## RESPONSES TO COMMENTS ON DRAFT EIS/R

This Response to Comments document responds to comments received on the South Bay Salt Pond (SBSP) Restoration Project Phase 2 Draft Environmental Impact Statement/Report (EIS/R). The Draft EIS/R identified the environmental consequences associated with the implementation of the SBSP Restoration Project Phase 2 actions, as well as mitigation measures to reduce significant and potentially significant impacts. As a result of comments received, the Draft EIS/R has been revised. The revised Draft EIS/R, together with this Response to Comments document, constitutes the Final EIS/R for the proposed SBSP Restoration Project Phase 2.

Figure 1. 2.2 km distances from outboard edges of R4, R3 and SF2.

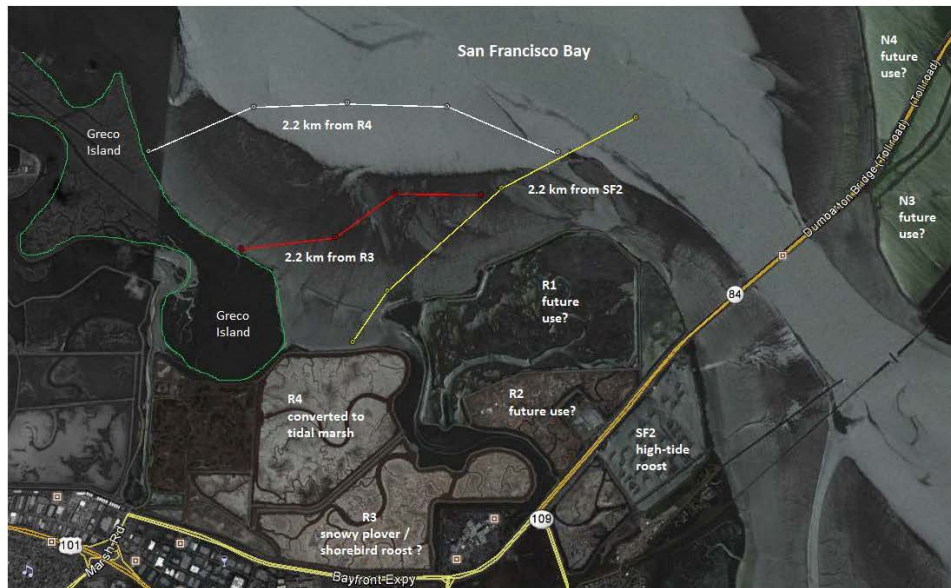
mudflats outboard of Greco Island may be underutilized by some shorebirds due to a lack of nearby roosting sites (Fig. 1). The privately-owned Redwood City Cargill ponds may not be available in the future for high-tide roosting.
